**FINAL EXPRESS TERMS  
FOR  
PROPOSED BUILDING STANDARDS  
OF THE  
CALIFORNIA STATE LANDS COMMISSION**

**REGARDING PROPOSED CHANGES TO  
THE CALIFORNIA BUILDING CODE  
CALIFORNIA CODE OF REGULATIONS, TITLE 24, PART 2  
CHAPTER 31F – MARINE OIL TERMINALS**

**2016 CALIFORNIA BUILDING CODE  
TRIENNIAL CODE CYCLE**

**FIGURE 31F-4-2**  
**PILE-DECK CONNECTION MODELING FOR**  
**PRESTRESSED CONCRETE PILE**  
**(ADAPTED FROM [4.2])**

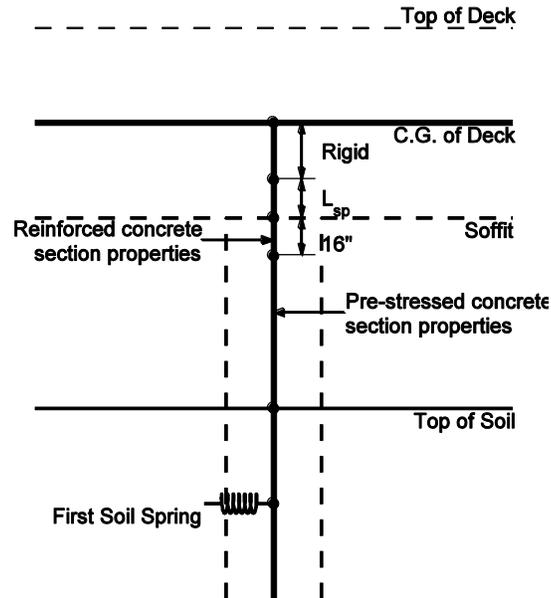
4.12. Add new Figure 31F-4-2:

**FIGURE 31F-4-4**  
**IDEALIZATION OF PUSHOVER CURVE (ADAPTED FROM [4.3])**

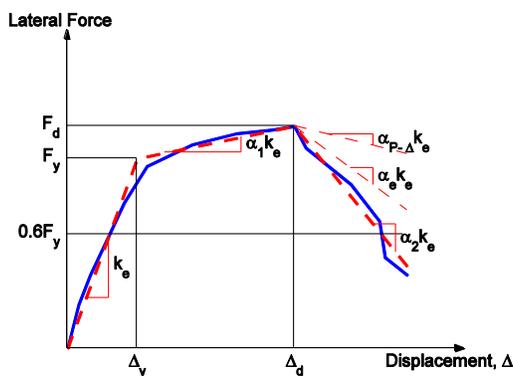
4.19. Add new Figure 31F-4-4:

**FIGURE 31F-4-5**  
**EFFECTIVE STIFFNESS,  $k_e$  [4.1]**

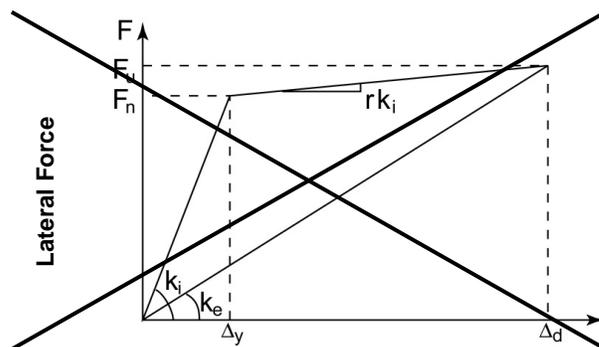
4.26. Remove entirely:

**FIGURE 31F-4-7**  
**EFFECTIVE LATERAL STIFFNESS (ADAPTED FROM [4.4])**

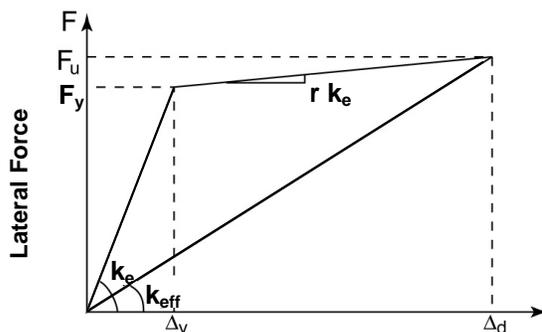
4.27. Add new Figure 31F-4-7:

**FIGURE 31F-4-9**  
**PLAN VIEW OF WHARF SEGMENT UNDER X AND Y SEISMIC EXCITATIONS**

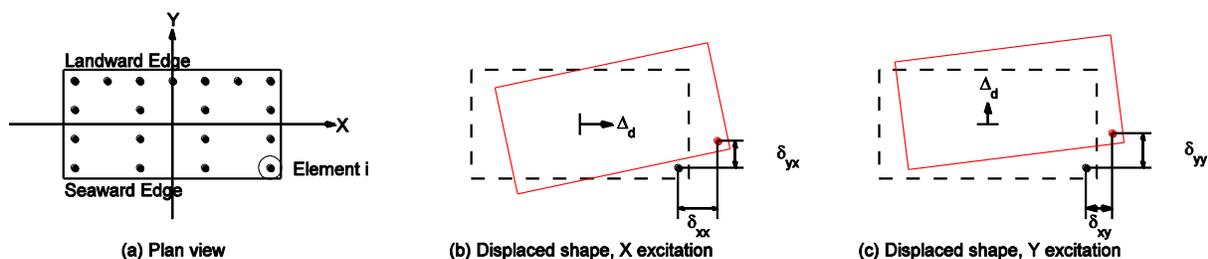
4.34. Remove entirely: **FIGURE 31F-4-7 PLAN VIEW OF WHARF SEGMENT UNDER X AND Y SEISMIC EXCITATIONS [4.3]**

4.35. Add new Figure 31F-4-9:

**FIGURE 31F-6-1**  
**AXIAL SOIL SPRINGS [6.8]**

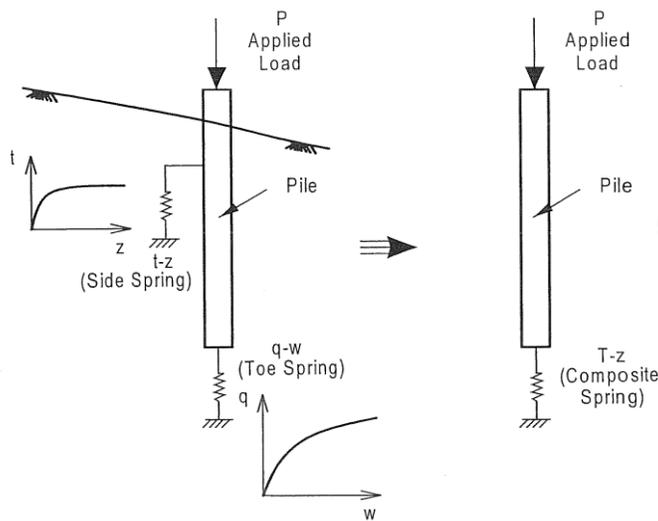
6.23. Add new Figure 31F-6-1 :

**FIGURE 31F-6-2**  
**SLIDING LAYER MODEL [6.8]**

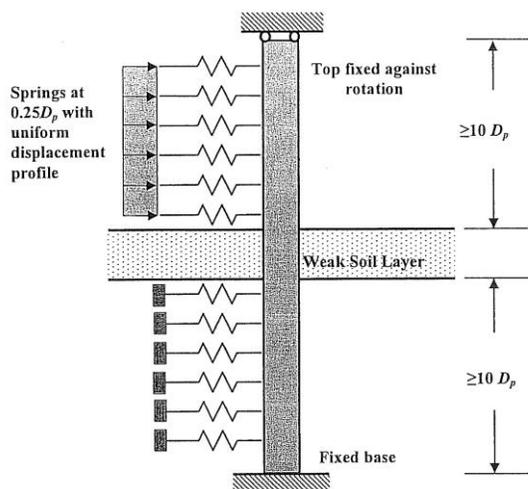
6.29. Add new Figure 31F-6-2 :

**FIGURE 31F-7-4**  
**INFLUENCE OF PILE/SOIL STIFFNESS RATIO ON PLASTIC HINGE LENGTH (after Fig 5.30 of [7.1])**

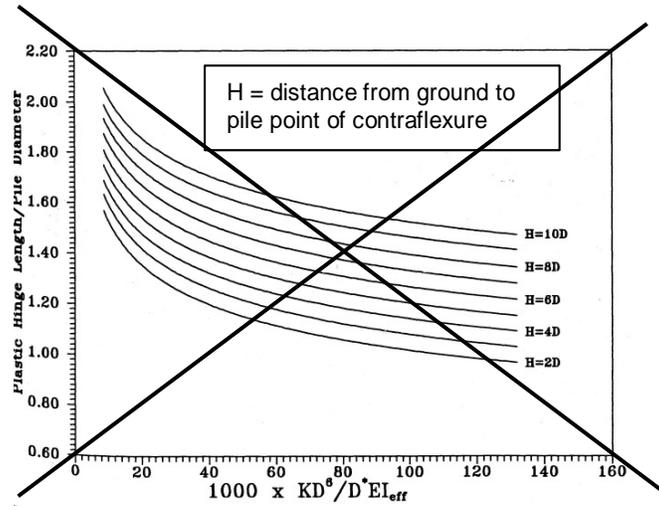
7.2. Remove entirely:

**FIGURE 31F-7-4 31F-7-5**  
**METHOD A – MOMENT CURVATURE ANALYSIS**

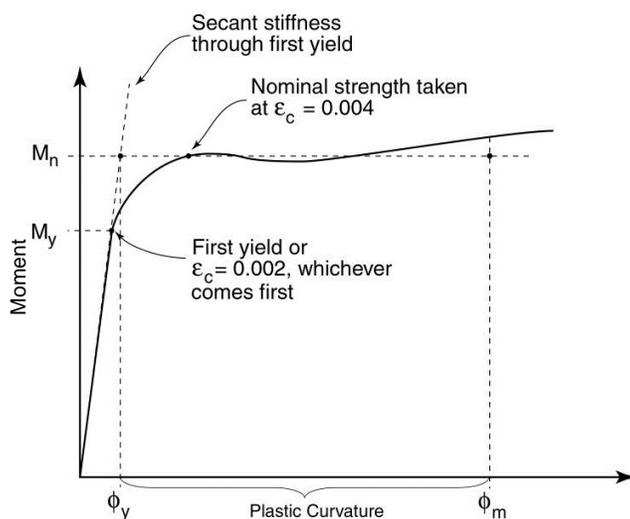
7.5. **3107F.2.5.4 Plastic rotation.** ~~The plastic rotation,  $\theta_{pr}$ , can be determined from Equation 7-8, by using moment-curvature analysis and applicable strain limitations, as shown in Figure 31F-7-5.~~

7.7.

**FIGURE 31F-7-5**  
**METHOD B – MOMENT CURVATURE ANALYSIS [7.6]**

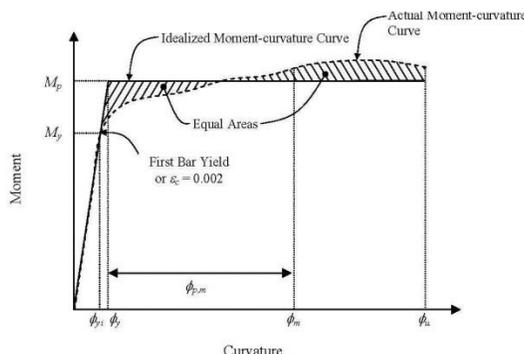
- 7.8. **3107F.2.5.4.2 Method B.** For Method B, the elastic portion of the idealized moment-curvature curve is the same as in Method A (see Section 3107F.2.5.4.1). However, the idealized plastic moment capacity,  $M_p$ , and the yield curvature  $\phi_y$ , is obtained by balancing the areas between the actual and the idealized moment-curvature curves beyond the first yield point (see Figure 31F-7-5). Method B applies to moment-curvature curves that do not experience reduction in section moment capacity.

7.9. Add new Figure 31F-7-5:
